PROJECT NAME: CHILDERS ROAD SUBDIVISION
DRAWING TITLE: ZONING PLAN

DATE: 08/06/2015
DRAWING NUMBER: Z-01
WALSH PROJECT NO.: 2014000000.00.AT

PETITION NO: Z-92

ZONING COMMENTS:

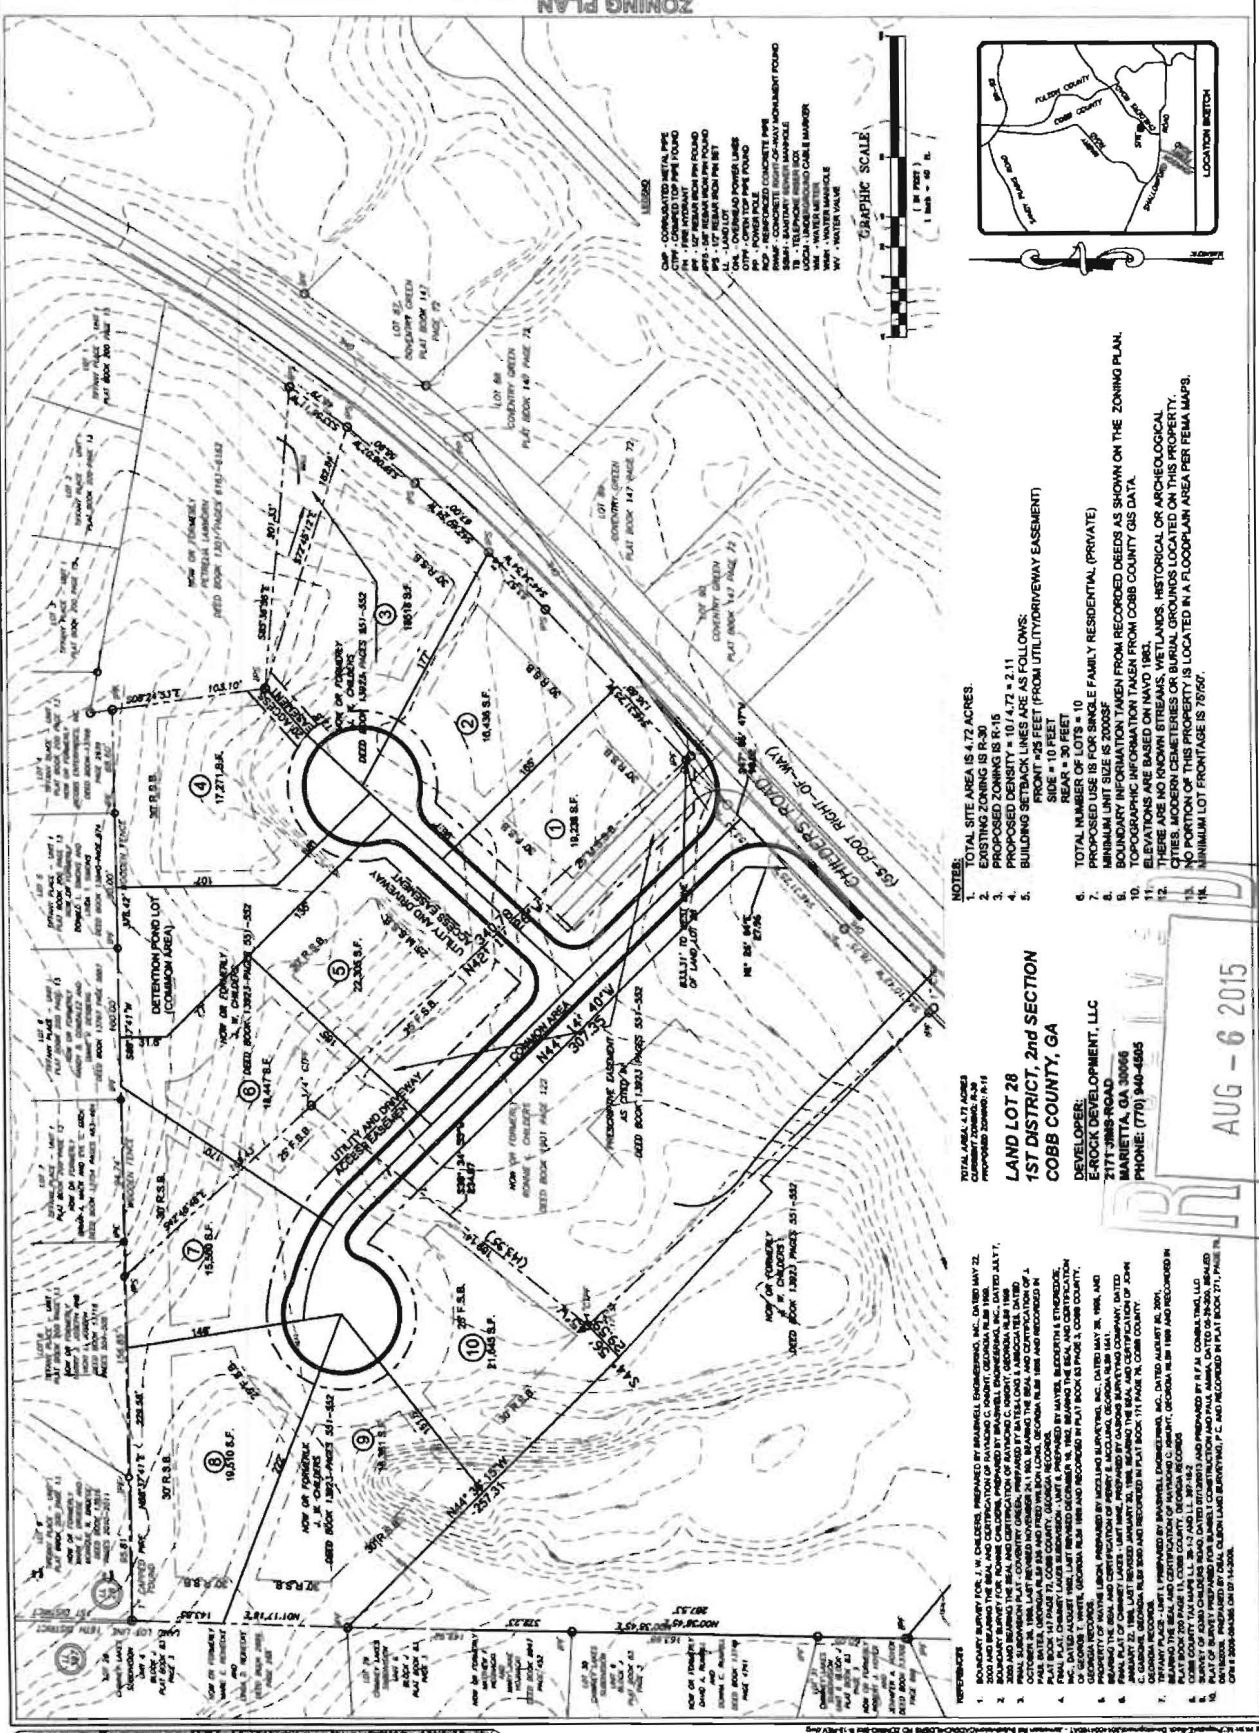
- No Stormwater controls shown _____
- Copy of survey is not current – Additional comments may be forthcoming when current site conditions are exposed.
- No site improvements showing on exhibit.

1. This site is located just northwest of Childers Road. Average slopes are relatively flat to moderate with maximum of 15%. The site cover is a mixture of open and wooded areas. The majority of the site (2/3) drains to the north into Tiffany Place Subdivision. The rear third drains into the Chimney Lakes Subdivision.

2. The detention facility must be tied directly to the existing downstream system within Tiffany Place S/D (Lot 4). The current channel conveyance through this lot does not have adequate capacity to handle the proposed increased runoff volume.

3. The majority of lots 7-9 will naturally bypass the detention pond. A drainage easement will be required at the rear of lots 4-8 to convey site runoff to the pond. Grading or landscape walls will likely be required to direct all impervious lot runoff to this easement.

Childers Road is classified as a minor collector and according to the available information the existing right-of-way does not meet the minimum requirements for this classification.

Recommend applicant verify that minimum right-of-way is available for Childers Road and if it is not, recommend applicant consider entering into a development agreement pursuant to O.C.G.A. 36-71-13 for dedication of the following system improvements to mitigate traffic concerns: a) donation of right-of-way on the west side of Childers Road, a minimum of 30' from the roadway centerline.

Recommend taper for the Childers Road access.

Recommend a no access easement along the lots that border Childers Road.

Recommend curb and gutter along both sides and sidewalk along one side of proposed development roadways.

- Site plan received by the Zoning Division on August 6, 2015, with the District Commissioner approving minor modifications;
- Fire Department comments and recommendations;
- Sewer and Water Department comments and recommendations;
- Stormwater Management Division comments and recommendations;
- Department of Transportation comments and recommendations; and
- Owner/developer to enter into a Development Agreement pursuant to §36-71-13 for dedication of system improvements to mitigate traffic concerns.
